AD/RHIC-AP-43

R.F. Accelerating Cavities for RHIC

MEMORANDUM

DATE: January 16, 1987
TO: E. B. Forsyth
FROM: J. G. Cottingham *JGC*
SUBJECT: R.F. Accelerating Cavities for RHIC

Fig 1

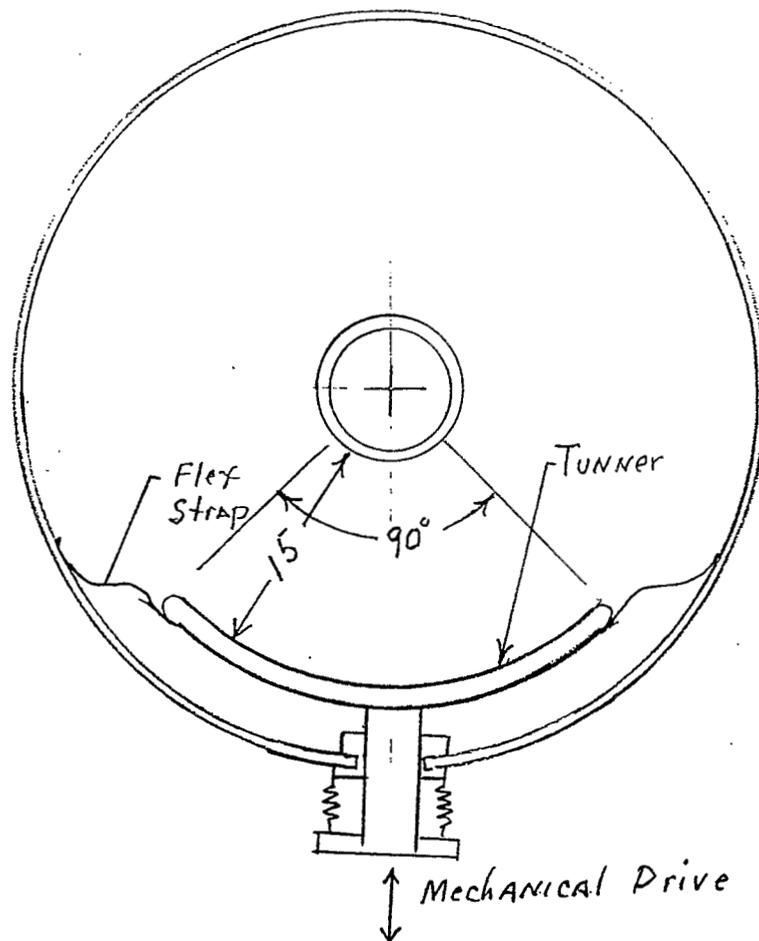
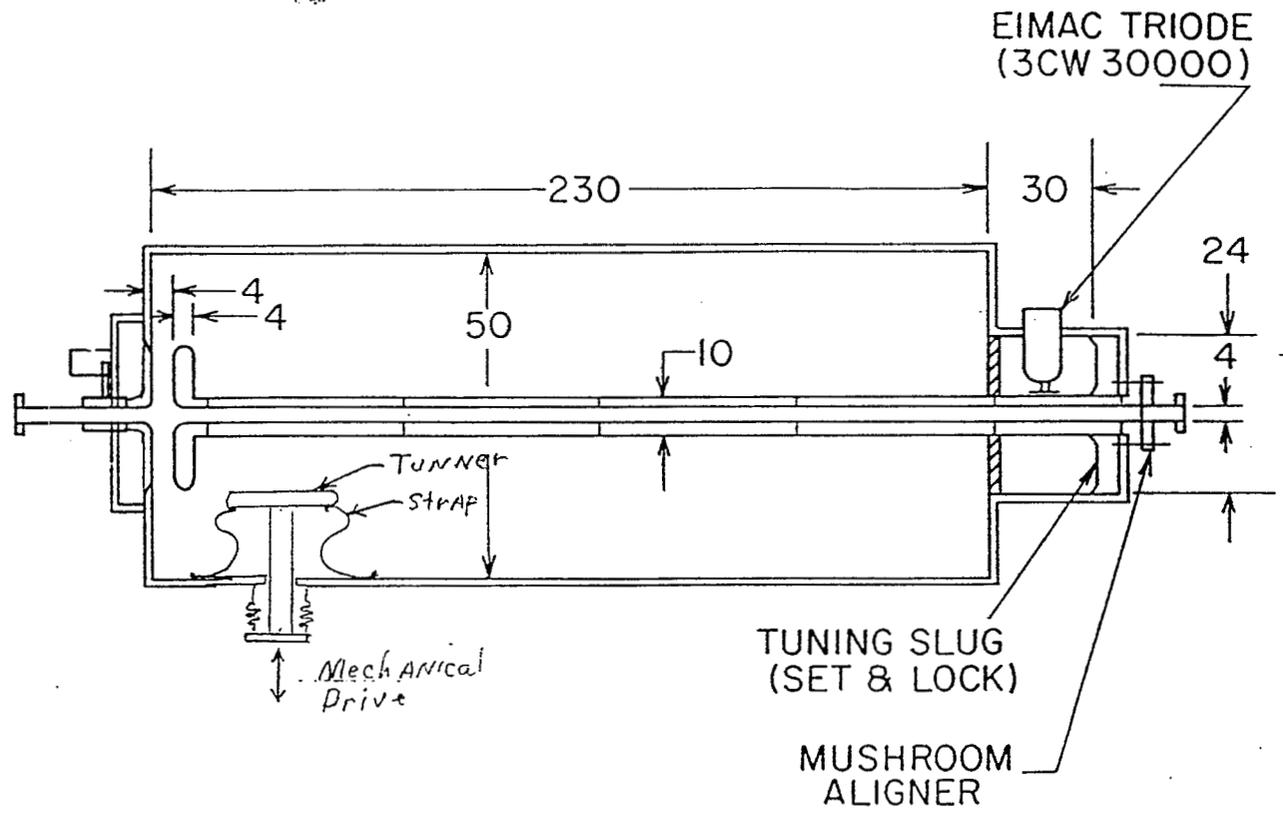
I have also reviewed the high voltage r. f. cavity design described by M. Puglisi in RHIC Technical Note No. 6. As you know this cavity design was the basis for the design presented in the RHIC Conceptual Design where it was modified to include a frequency tuning feature, (see page 241). The design is sound with one exception. I don't like using the accelerating gap spacing as a means of adjusting the frequency. I believe that stress flexure and motion should be avoided in this high gradient region. Instead I would suggest a "side" tuning plunger which I believe is more conventional. I have sketched a design of this type, (see attached Fig. 1).

This plunger is mechanically positioned by an external mechanism working through a bellows to accomplish the desired tuning. The electrical connection to the plunger is accomplished by flexible copper straps. Sliding r.f. joints in a vacuum is in my view a no-no. The required motion for normal operation is small, see attached tuning-position curve, but the full range requested in the Conceptual Design is available.
